AMENDMENT OF SOLICITATION/MODIFICATION OF CONTRACT	BPA NO.	1. CONTRACT ID CODE	PAGE 1	OF 11

The purpose of this modification is to add the attached statement of work for refurbishment of the OWFN restrooms located in the elevator lobbies.
The contractor shall provide performance and payment bonds for 100% of the value of this modification within 7 calendar days after the effective date.
Task order ceiling: $1,615,323.23 (CHANGED)
Total obligated amount: The total obligated amount is increased by $175,164.70 from $1,440,158.53 to $1,615,323.23 (CHANGED)
Period of performance: October 1, 2011 through November 27, 2012 (CHANGED)
Contractor POC: Frank Zawitoski, **email: frankz@biscayne-contractors.com**; Matt Conologue, email: **mattc@biscayne-contractors.com**, phone: 703-562-5619, cell: 703-772-4557
NRC project officer: Bill Harris, email: william.harris@nrc.gov, phone: 301-492-3651, cell: 240-375-2661

Contract NRC-HQ-11-C-10-0074, Task Order NRC-HQ-11-T-10-0001, Change Order 3
STATEMENT OF WORK
Change Orders to One White Flint North Elevator Lobby/Restroom Refurbishment (OELRR) Project Phase II – Floors 1, 3, 4, 6, 7, 8, & 15

3RD-16 & 14TH FLOOR FINISH PLAN

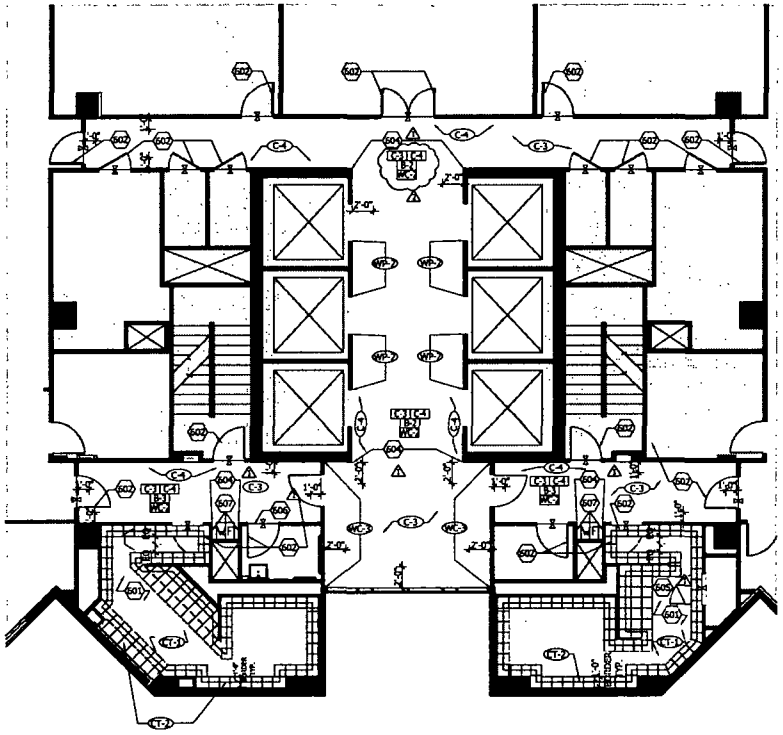
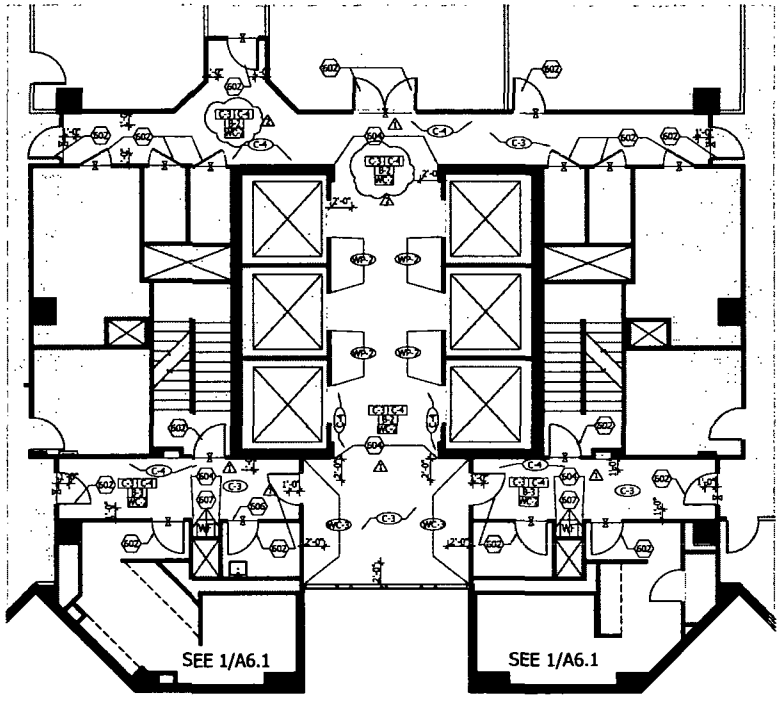
h) Substitute "METAL WEAVE" N439 Argent Silver 2 with MDW8013 Gallatin Silver for floors: 3, 4, 6, 7, 8, and 15 to maintain consistency from Phase I.
i) Replace the last panel with a shorter panel of the last toilet stall in the first floor men's restroom. Replace two floor tiles after removing existing partition.

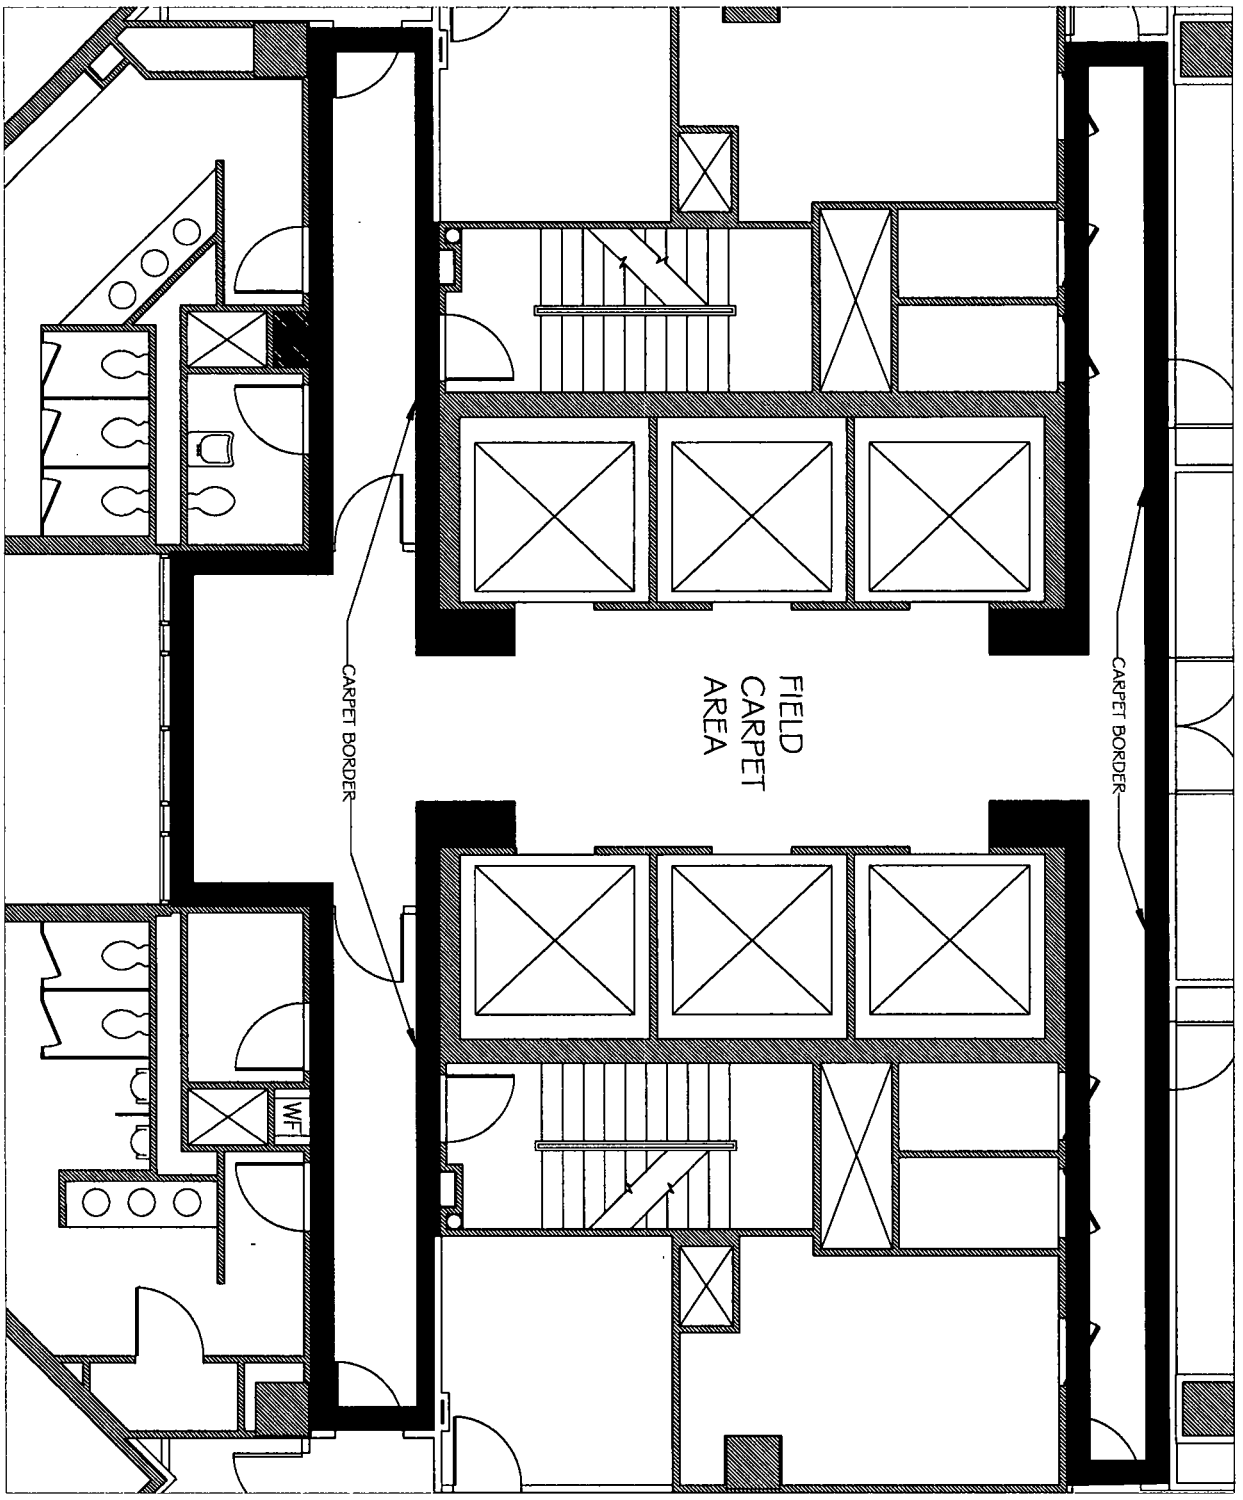
f) Elevator Lobby field carpet to run along all six elevators in place of border carpet, see attached drawing, 'OELRR Carpet Layout'.
g) Add two additional rows of white field wall tiles in the 1st floor women's restroom.
